Airways New Zealand updated submission to the Civil Aviation Authority's 2018 Nelson and Marlborough Airspace Review

Prepared by: John Wagtendonk
Policy, Standards and Safety Improvement
Airways New Zealand

UPDATED 12 February 2018

Below is the Airways New Zealand (Airways) updated submission to the CAA 2018 Nelson and Marlborough Airspace Review. This submission replaces our earlier submission dated 11 January 2018.

Diagram 7 Draft CTA to the north

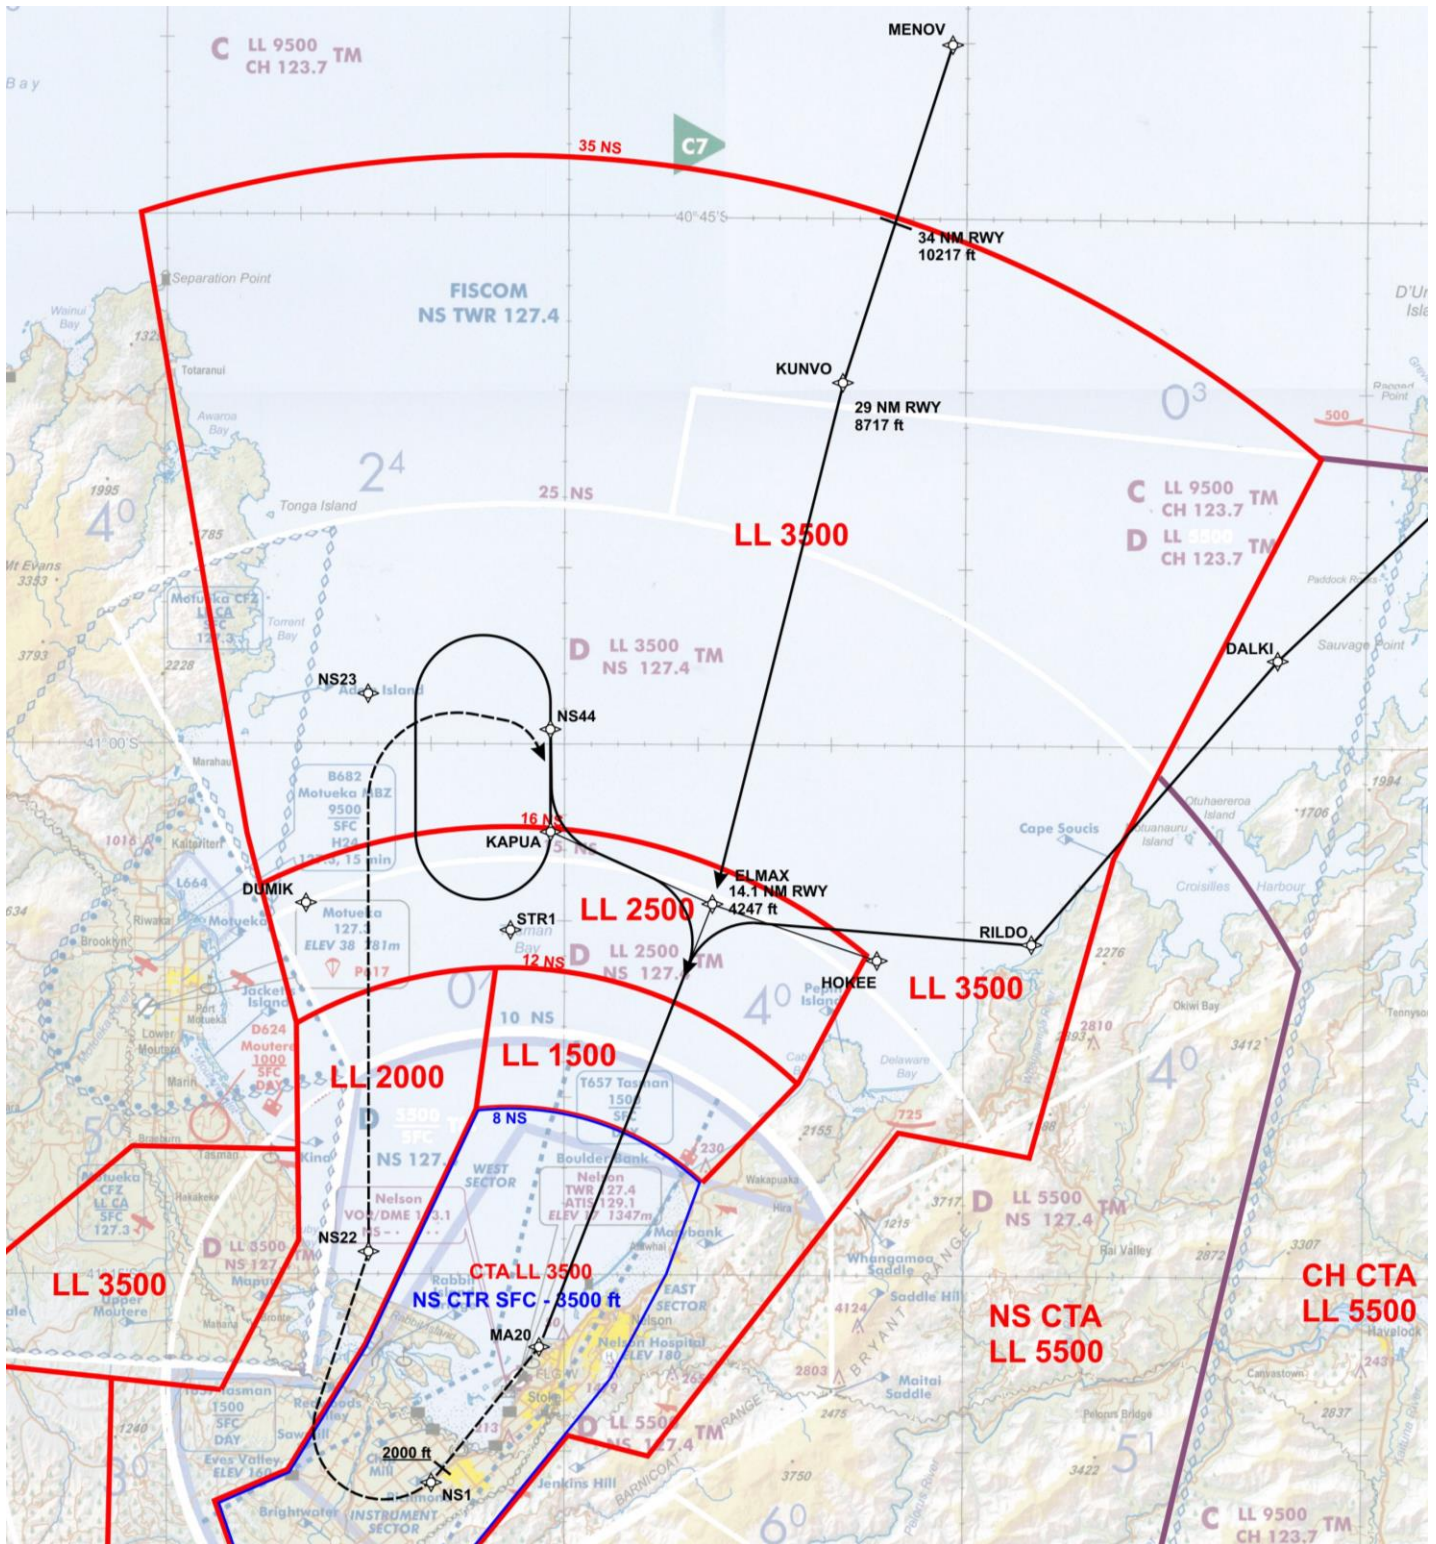
The extensive CTA LL 3500 ft to the north of Nelson is required to provide airspace containment for the planned new missed approach holding pattern at KAPUA and the holding pattern at ELMAX. CTA below 10,000 ft is also needed out to 35 NM NS to contain the descent profile of the new PBN arrival to RWY 20 via MENOV and KUNVO waypoints.

Diagram 9 Draft CTA.
 Black line is the new PBN departure off RWY 20 to NZAA.

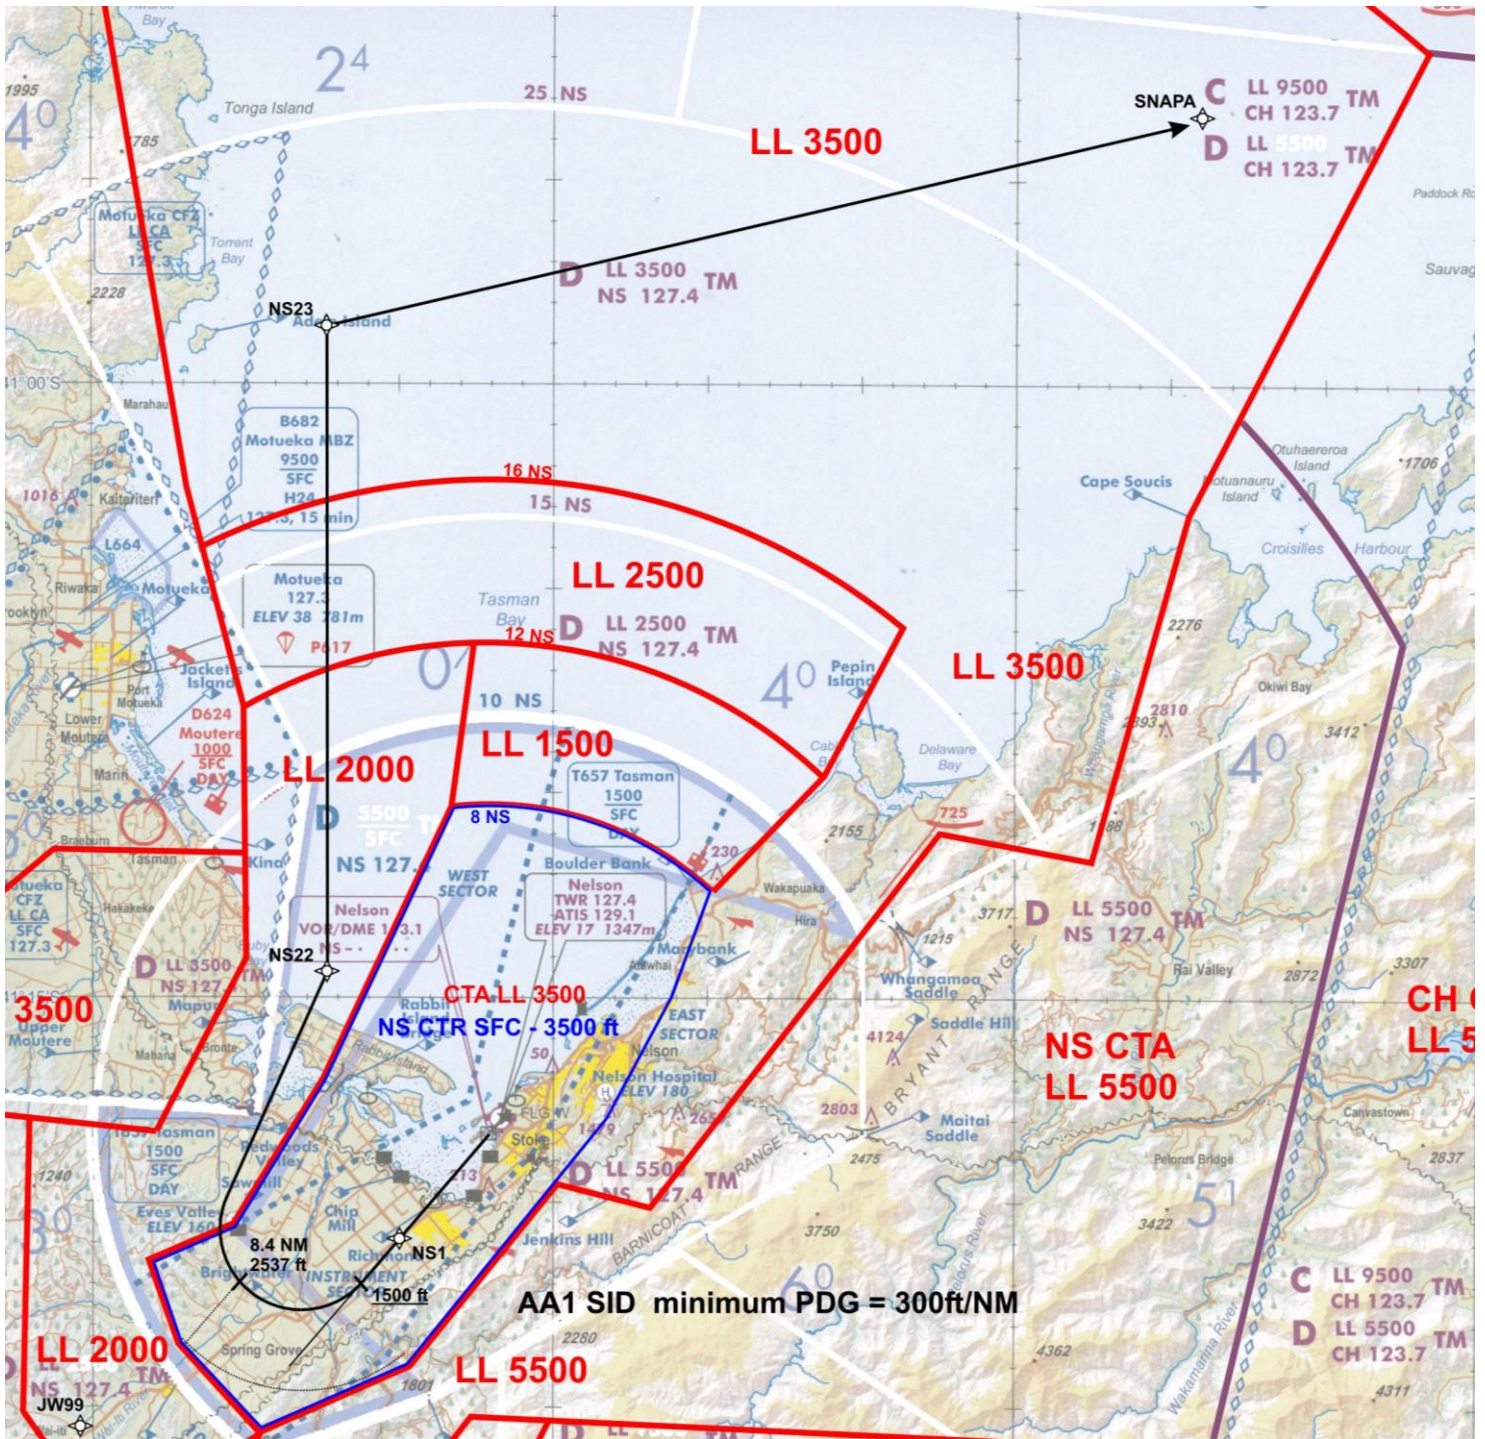
The new PBN SID to NZAA off RWY 20 is shown in Diagram 9 below. The CTA boundary near Ruby Bay provides the required 2 NM buffer from the RNAV departure.

Diagram 10 Draft CTA to the south.
The hang gliding and paragliding launch site at Inwoods Lookout
about 21 NM south-west of Nelson is depicted

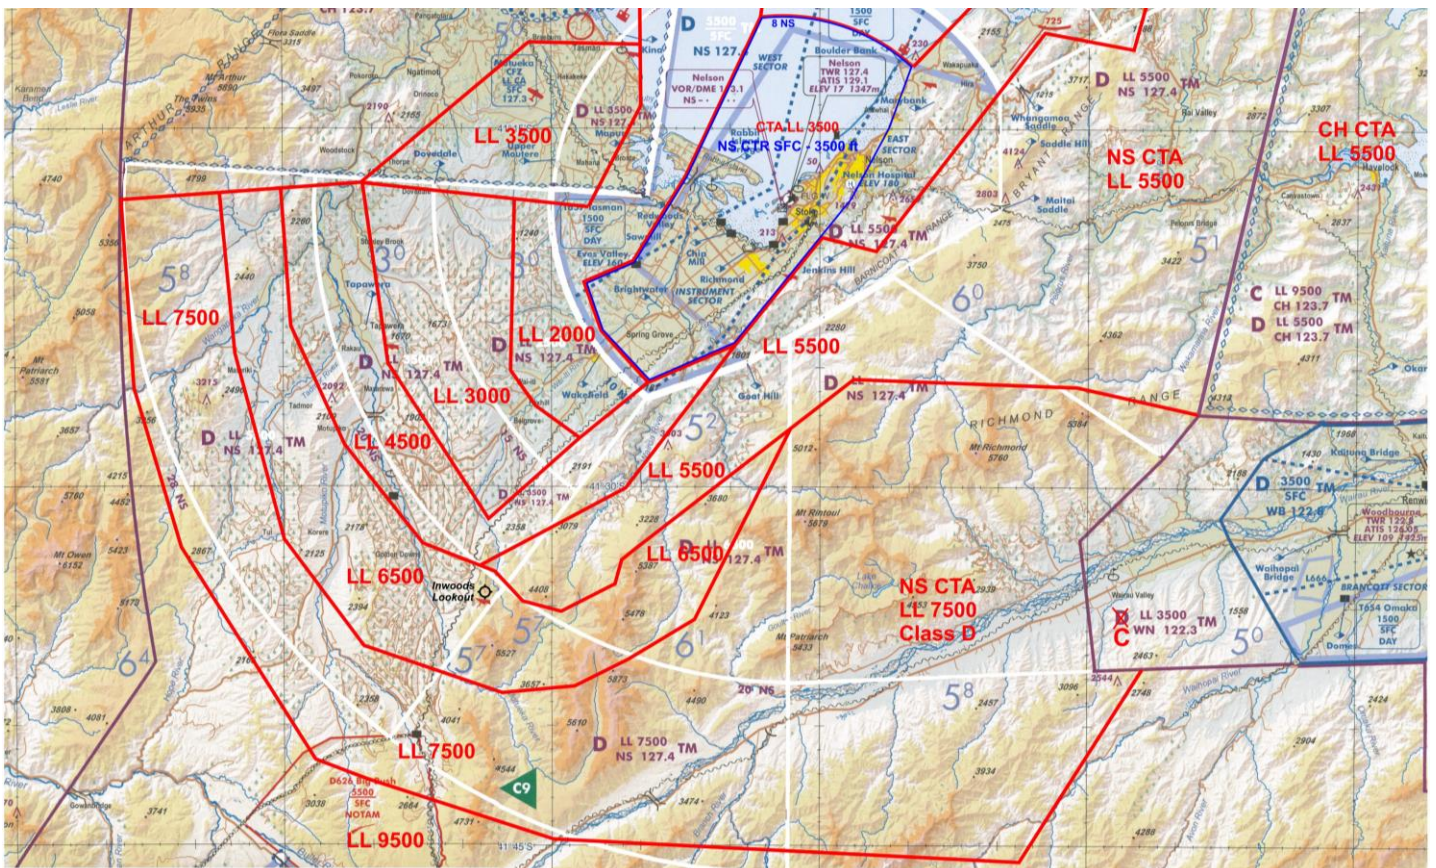
The draft CTA to the south is depicted in Diagram 10 below. This CTA is more complex than ideal due to the high and undulating terrain to the south and the airspace design rule that the lower limit of CTA must be at least 700 ft above terrain. Attempts to simplify the design by expanding a particular CTA were often prevented by a high point in the terrain that would result in the CTA be less than the required 700 ft above the terrain. Potentially, some of the CTA boundaries to the west-south-west of NS near Tapawera could be arcs from NS DME but these would result in some increase in CTA. The CTA boundary to the south near Inwoods Lookout ‘threads’ a fine line between providing the required airspace for containment of the IFR procedures (see Diagram 11), ensuring the CTA is at least 700 ft above the 5387 ft high terrain spot and providing as much class G airspace as practical for hang glider/paraglider operations from Inwoods Lookout launch site.

Airways is happy to work with operators and CAA to refine and simplify the boundaries where possible.

Diagram 13 Draft CTA to the south with RWY 20 departures to WN.

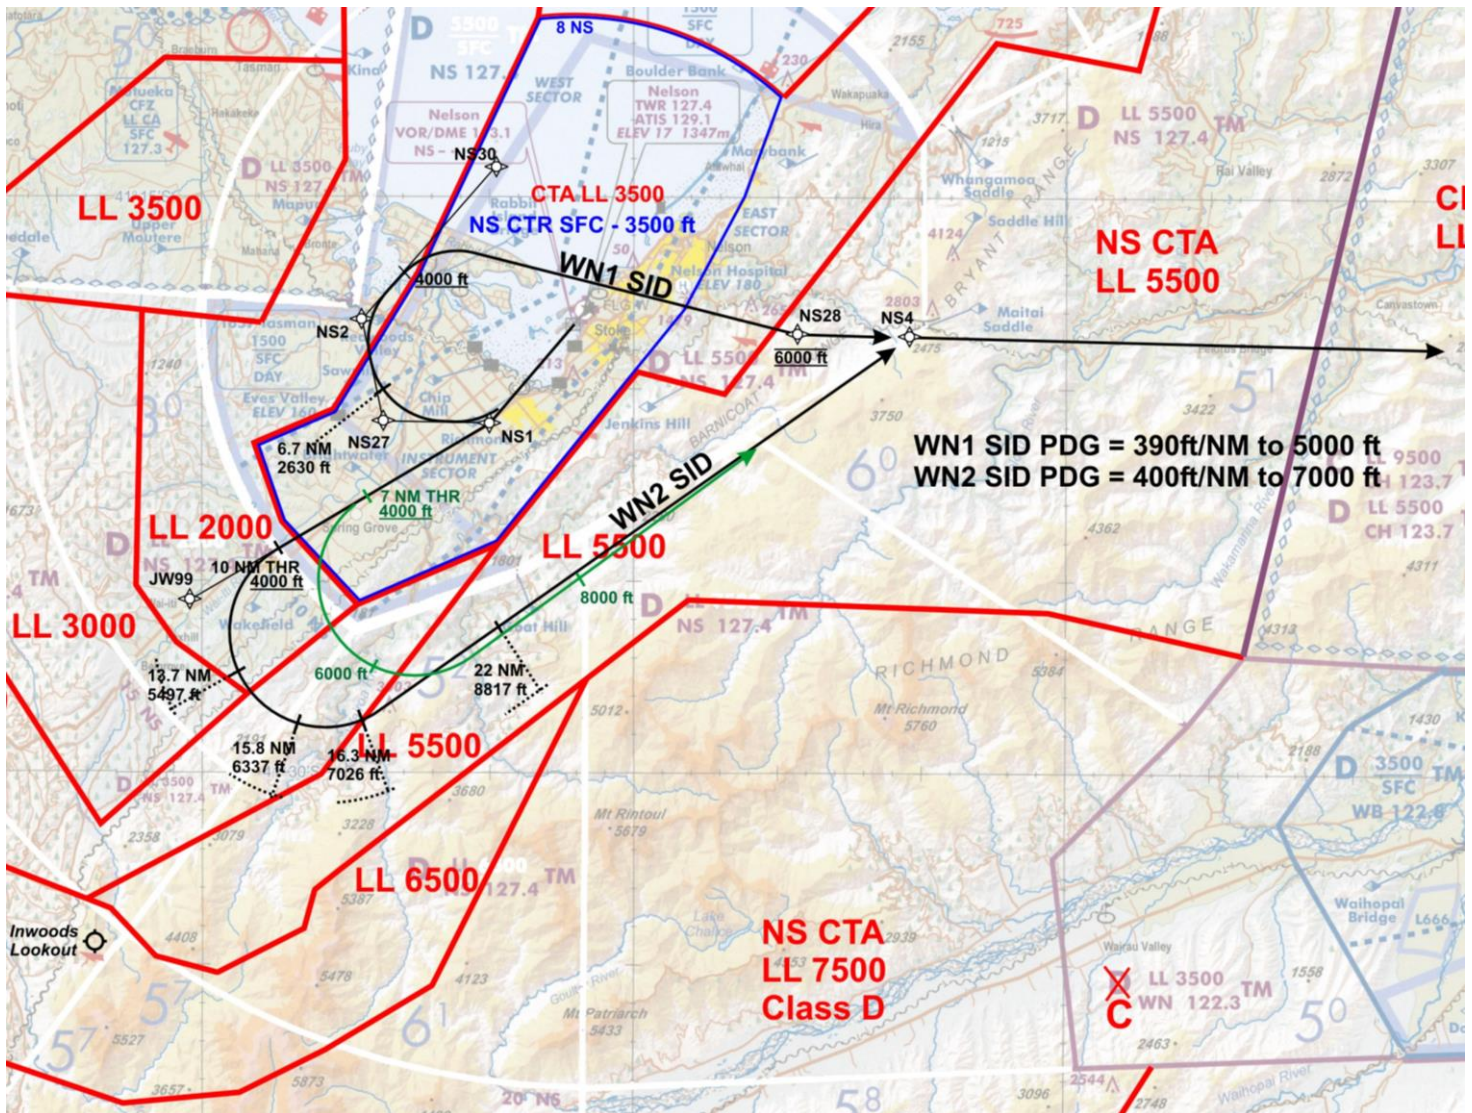
The WN departure to the south that turns left passing 4000 ft is depicted in two forms;

1. the black line is the nominal track when the aircraft climbs at the procedure's minimum gradient of 400 ft per NM (6.6%) to 7,000 ft;
2. the green line is the nominal track when the aircraft climbs at a steeper gradient of 570 ft per NM (9.4%) to 7000 ft.

The CTR and CTA are designed to contain that left-turning WN departure in both those climb gradient situations.

However, if an aircraft departing on this SID climbed steeper than 570 ft/NM (9.4%) to reach 4000 ft and turn left at NS1 or soon after, and then reduced climb gradient, airspace containment would not be assured (or is unlikely). To contain a departure profile such as that would require lowered CTA and possibly the CTR being moved eastward to about its current location - maybe a bit further. The Airways position is that such a climb profile is unlikely and our CTR/CTA design should not have to allow for that at the expense of increased CTR. We welcome input from operators and/or CAA if they see it differently and require the extended airspace to ensure the containment of such departure profiles.

Diagram 14 Google Earth image depicting THGPC launch site at Inwoods Lookout with nearby draft CTA boundaries depicted in red.

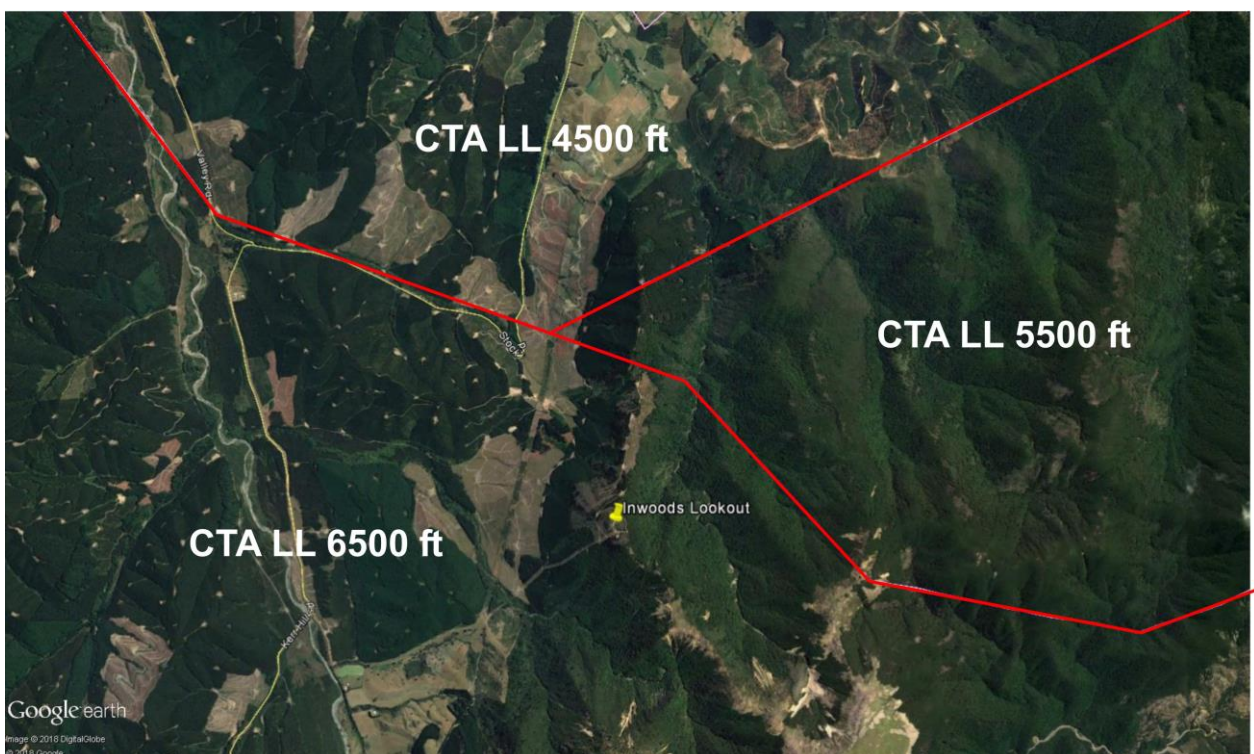
Diagram 14 below is a Google Earth image depicting the Inwoods Lookout site along with the nearby draft CTA boundaries.

Part of the 6500 ft/4500 ft CTA boundary lies immediately north of Stock Road.

Diagrams 11 and 12 depict the nearby instrument procedures to/from Nelson. These show that there is minimal, if any, room to reduce the CTA and provide the THGPC with more uncontrolled airspace in this area.

Diagram 15 The WB CTA that we are requesting classification change to Class C.

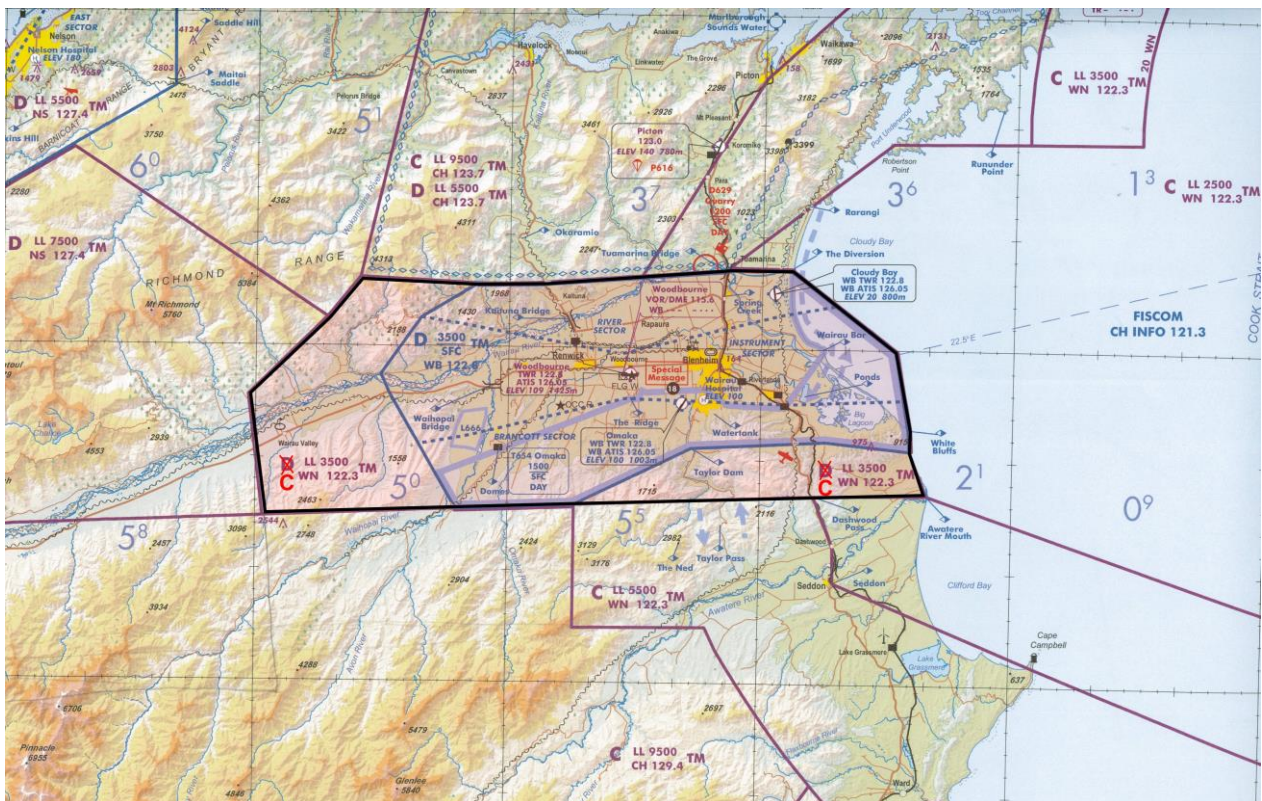
Separate to the requested Nelson airspace changes, Airways is requesting that the WB CTA 3500 ft to 9500 ft (NZA631), red highlighted in Diagram 15 below, is changed in classification from Class D to Class C.

This CTA block is controlled by WN Approach. All the CTA controlled by WN Approach around this particular CTA is Class C.

Changing this CTA block to Class C would enhance consistency of ATC service.
